NUMBER: 18-012-21 REV. A

Flash: Powertrain Control Module (PCM) Updates

2020	(DJ)	RAM 2500 Pickup
2020	(D2)	RAM 3500 Pickup

Fig. 2
Old Style Asymmetrical Cam Design Pump

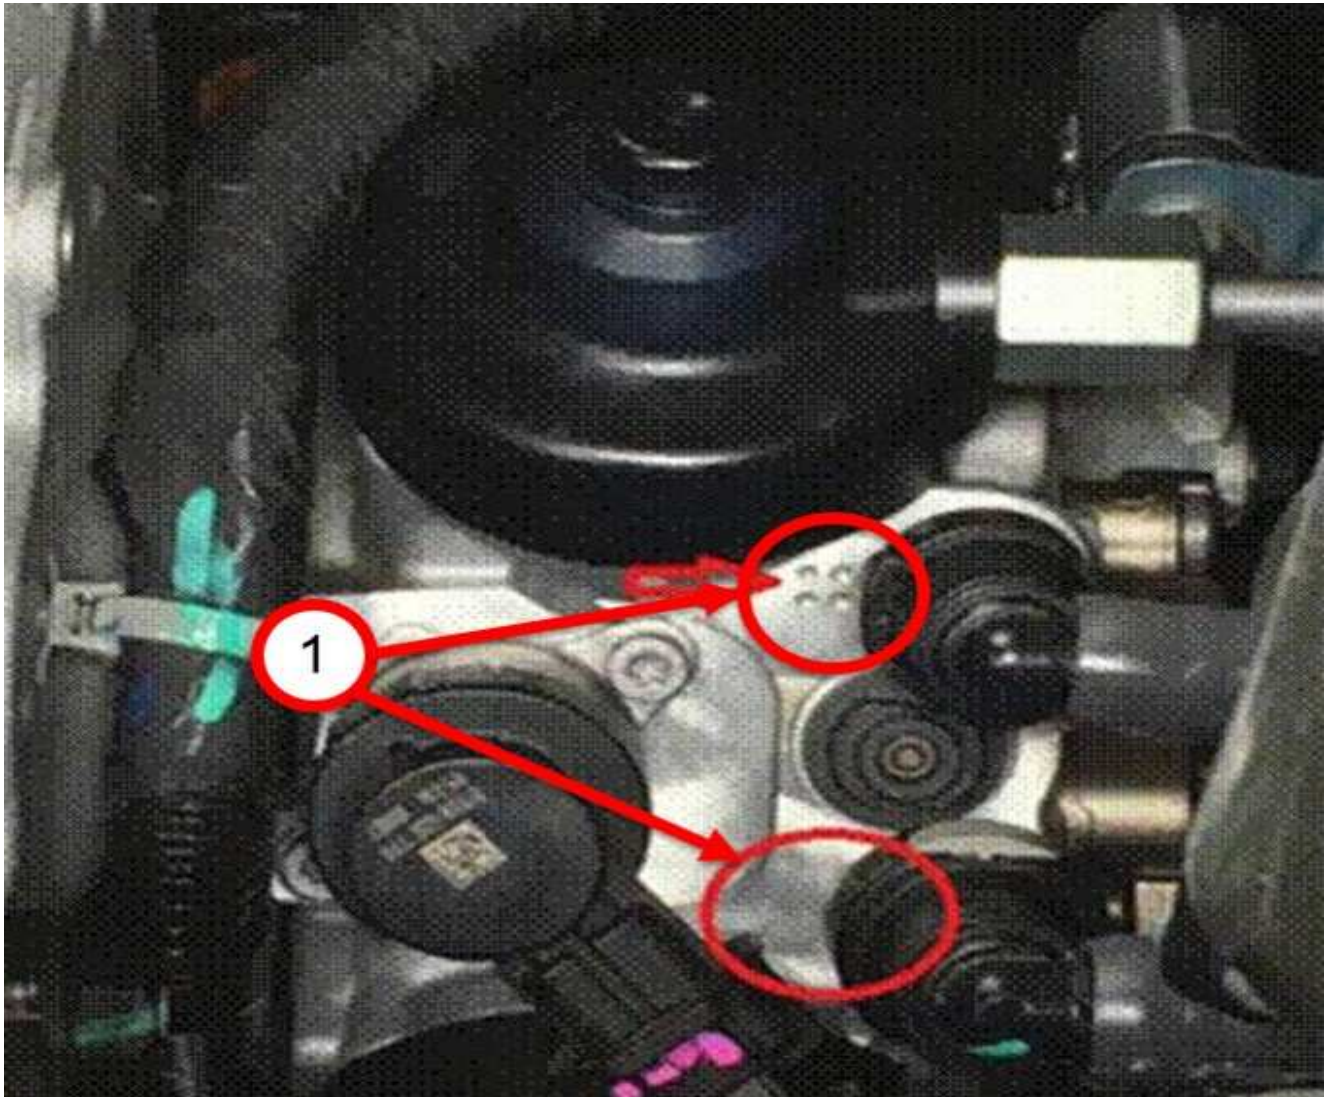
- Vehicles with the old style Asymmetrical Cam design will have multiple dots embossed in the pump housing (Fig. 2) .
- For vehicles with an Asymmetrical Cam pump, choose the calibration labeled Asymmetric Cam or Asym Cam.
